Bayside Planning Panel

Item No	5.1
Application Type	Development Application
Application Number	DA-2017/166
Lodgement Date	8 November 2016
Property	28 Highworth Avenue, Bexley
Owner	Mr John David Pitt
Applicant	Ms Neisha Pitt
Proposal	Alterations and additions to existing dwelling to convert to childcare centre catering for 28 children and 5 staff members operating Monday to Friday 7.30am – 6.00pm, high front fence and demolition of existing outbuilding.
No. of Submissions	15
Cost of Development	\$85,000
Report by	Fiona Prodromou, Senior Assessment Planner

Planning Assessment Report

Application Number:	DA-2017/166
Date of Receipt:	8 November 2016
Property:	28 Highworth Avenue, BEXLEY NSW 2207 Lot 46 DP 8760
Owner:	Mr John David Pitt
Applicant:	Ms Neisha Pitt
Proposal:	Alterations and additions to existing dwelling to convert to childcare centre catering for 28 children and 5 staff members operating Monday to Friday 7.30am - 6pm, high front fence and demolition of existing outbuilding
Recommendation:	Refused
No. of submissions:	15
Author:	Fiona Prodromou
Date of Report:	28 July 2017

GROUND FLOOR and SITE PLANS SCALE 1:100 @ A1

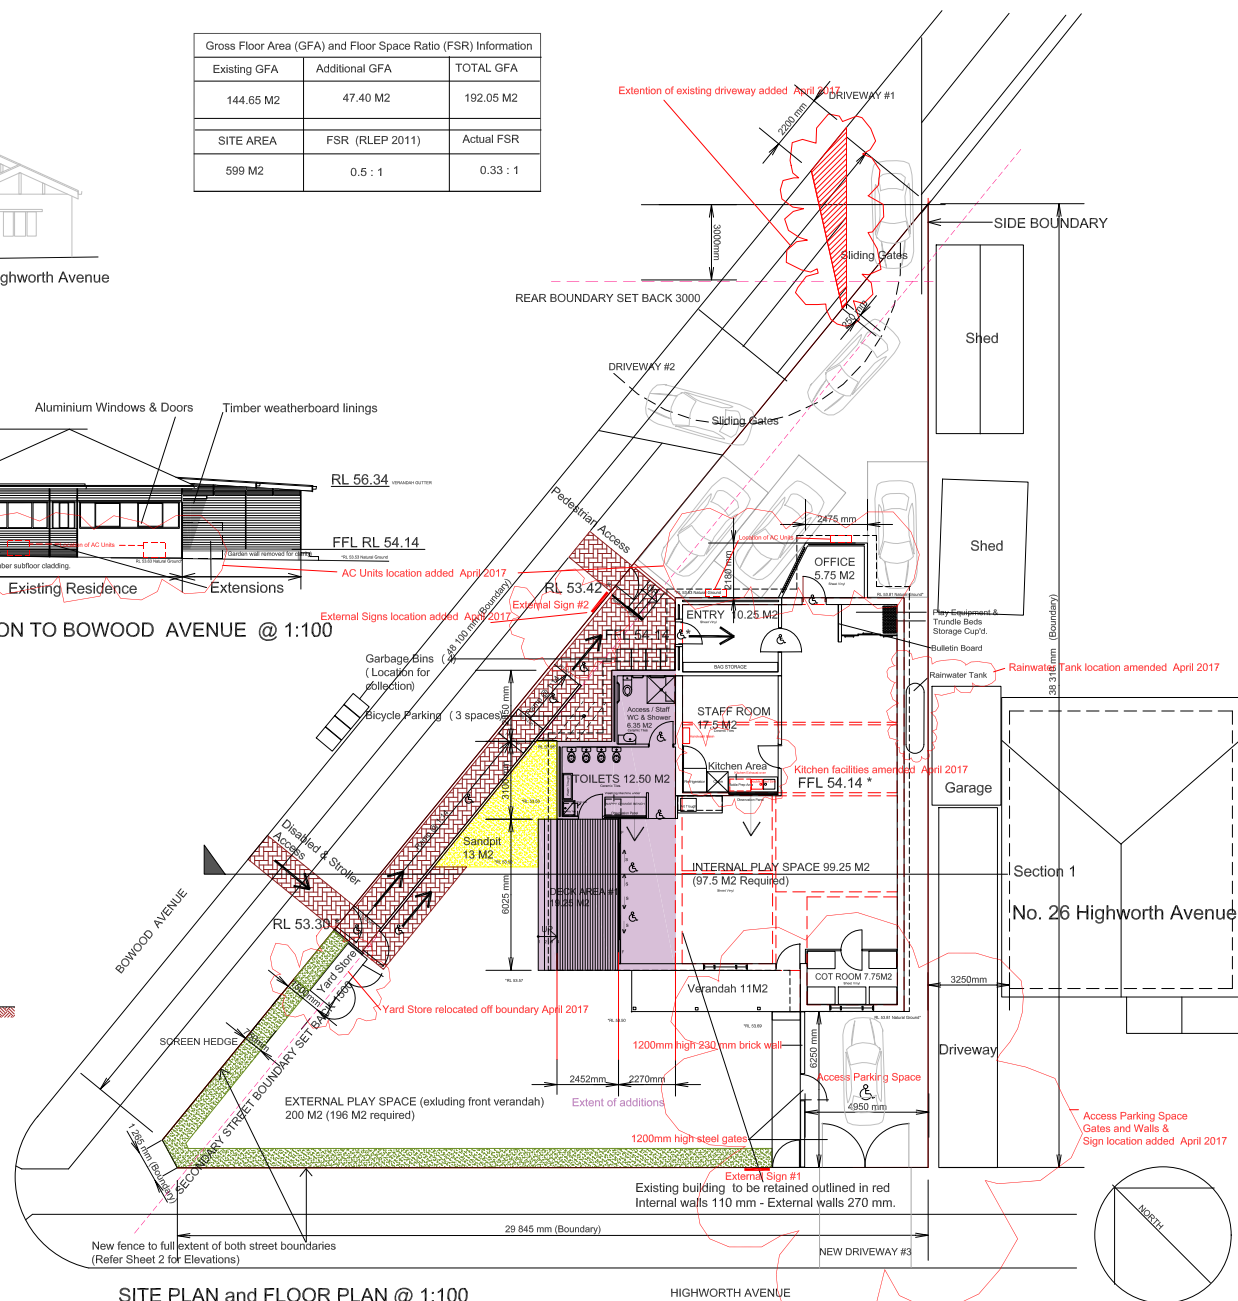
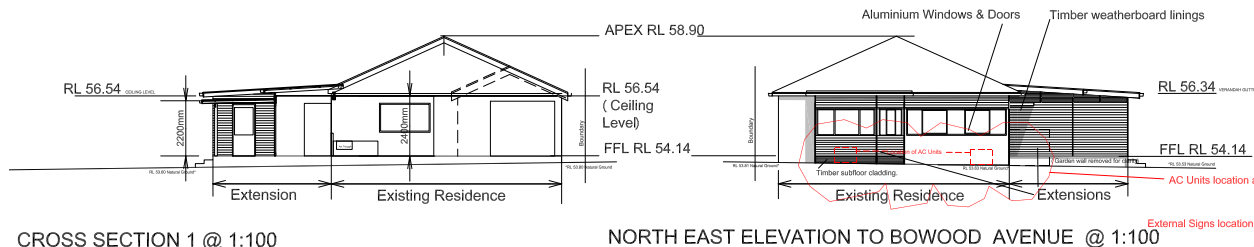
Plans illustrate the provision of a ramp to the main entrance of the facility in Bowood Avenue, in addition to an accessible car parking space located in Highworth Avenue.

The proposed accessible car parking space is disassociated from the main pedestrian entrance to the facility. Future users who park in this space would likely be required to traverse through the proposed outdoor play area in order to access the ramp leading to the main pedestrian entry to the facility. Architectural and landscape plans are inconsistent with respect to the proposed ramp, with landscape plans indicating no ramp leading down into the proposed outdoor play area thus resulting in a level difference of up to 0.26m between the proposed finished outdoor play area (53.50RL) and landing for the ramp (53.24RL). This level difference would require two steps and thus "access" is thwarted for the user.

Plans illustrate the provision of a waste storage area on site for 4 bins adjacent to the accessible ramp and main entrance to the proposed facility. This is not considered to be an appropriate location for waste storage for the proposed development and has the potential to be unsightly and generate offensive odours. The proposal is unsatisfactory in this regard.

1 LANDSCAPE SITE PLAN

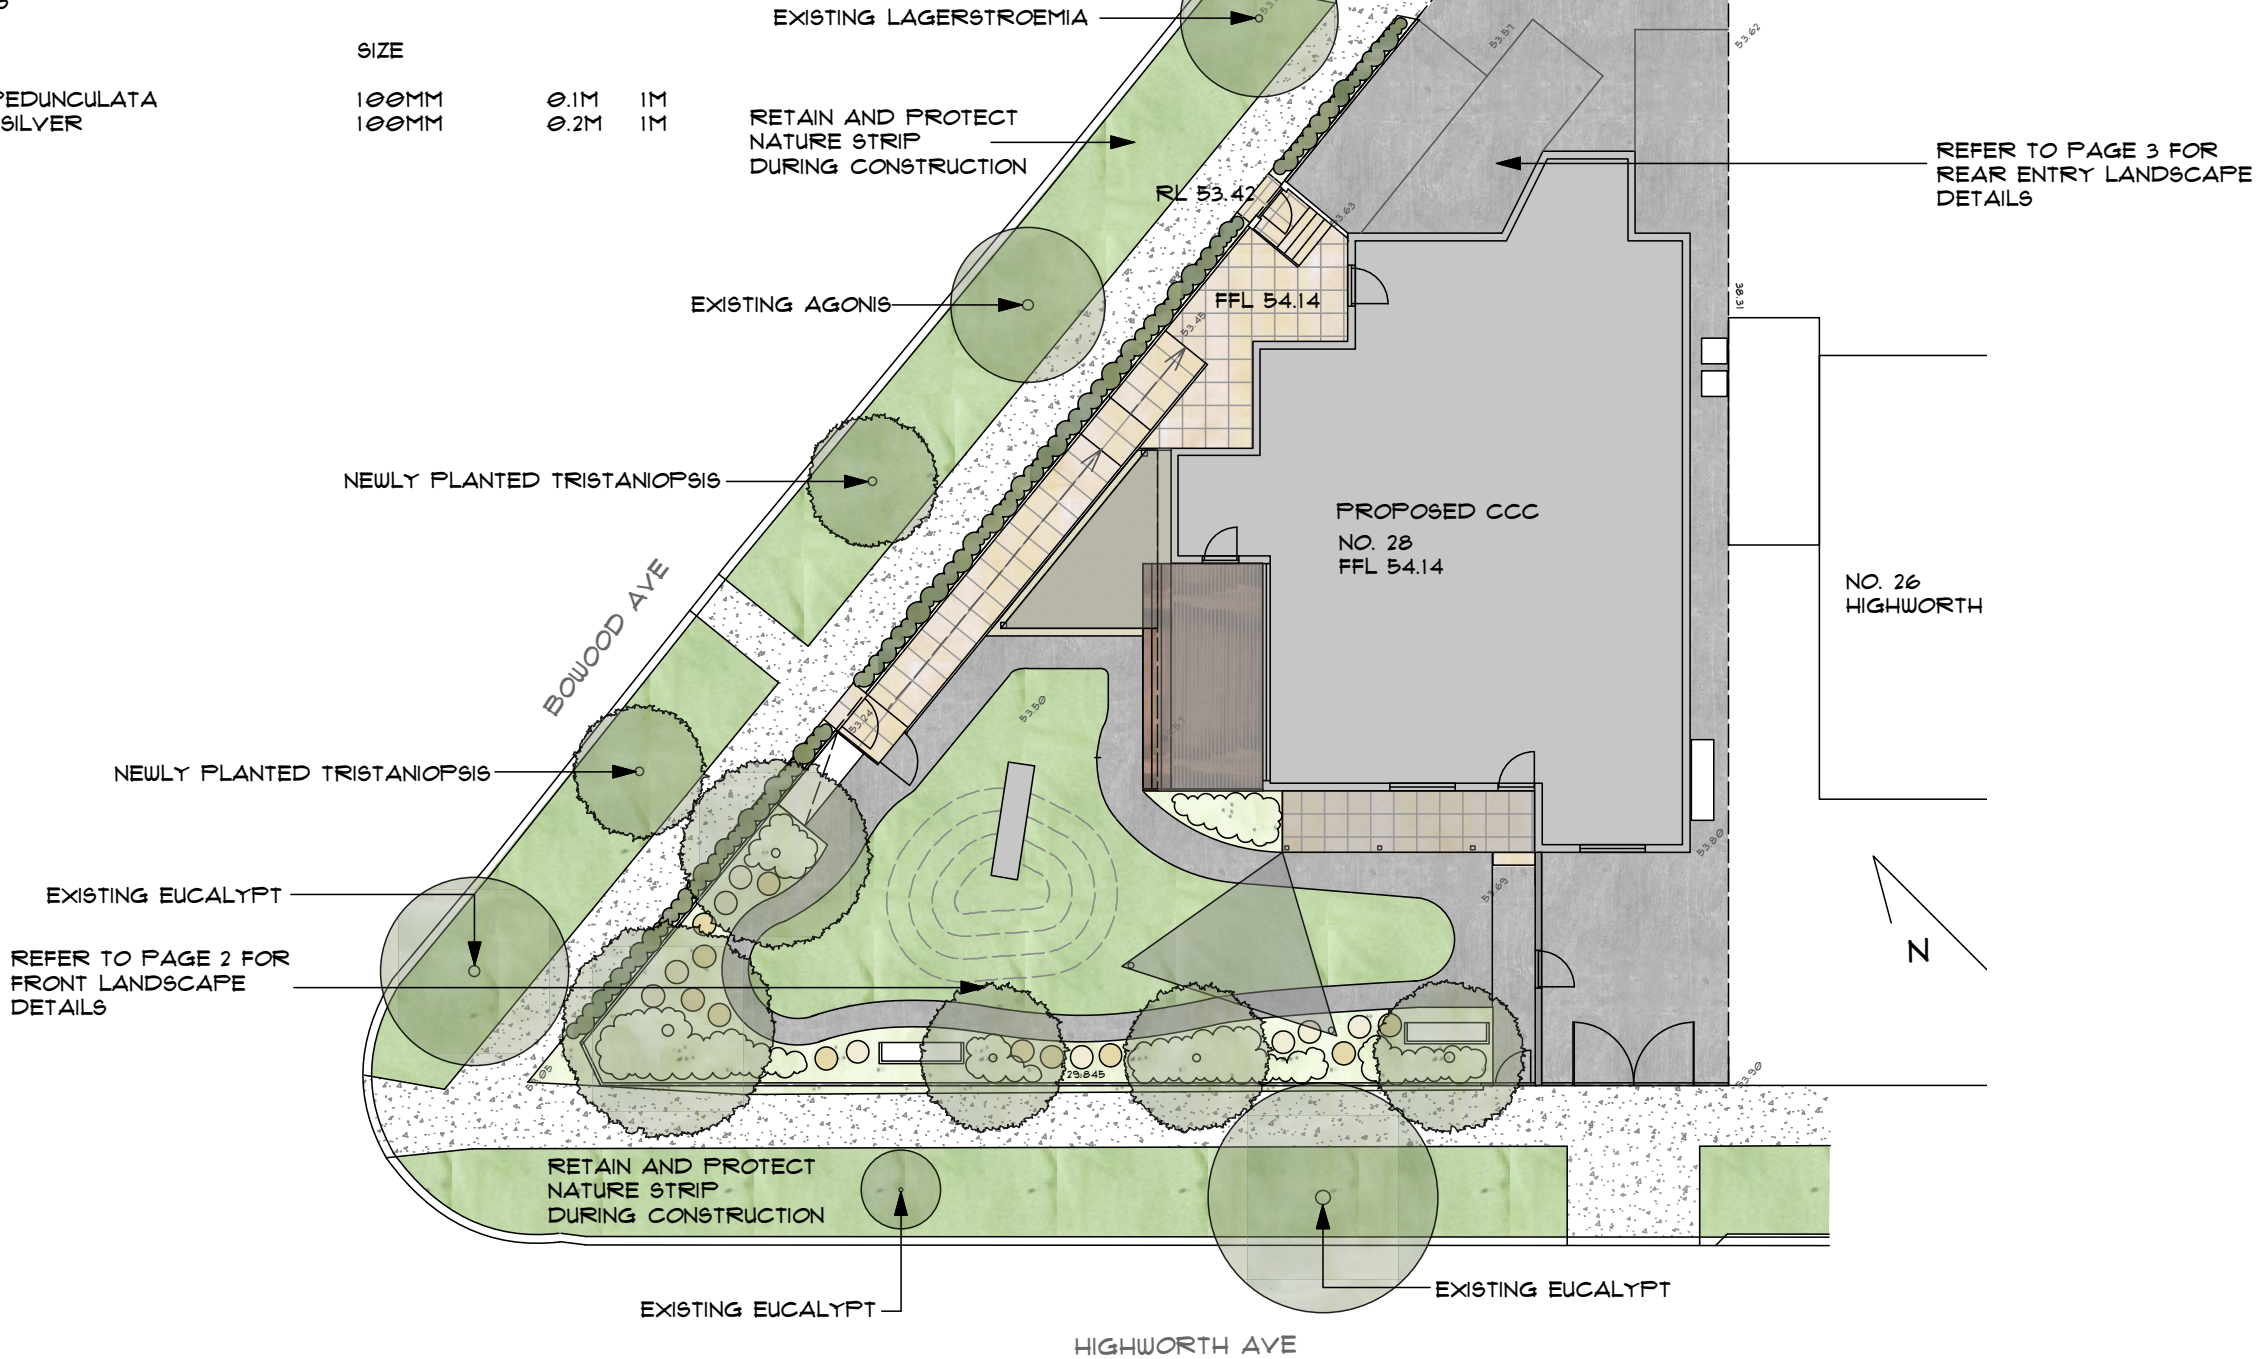
The submitted landscape plan (page 1 Issue A) illustrates the provision of 22.6% (135sq/m) of the site to be retained as 'landscaped area'.

Concern is raised in relation to the accuracy of this figure, as the landscape plan does not detail whether the 'lawn' areas proposed within the outdoor play area are comprised of natural or artificial turf. Plans further illustrate planters, proposed along the Bowood Avenue frontage of the site, which appear to be beyond the property boundaries of the site.

An accurate calculation of the landscaped area on site was not able to be calculated given the detail provided on the landscape plan obscures property boundaries and does not enable an accurate assessment. The proposal cannot adequately be confirmed to comply with the requirements or objectives of this clause.
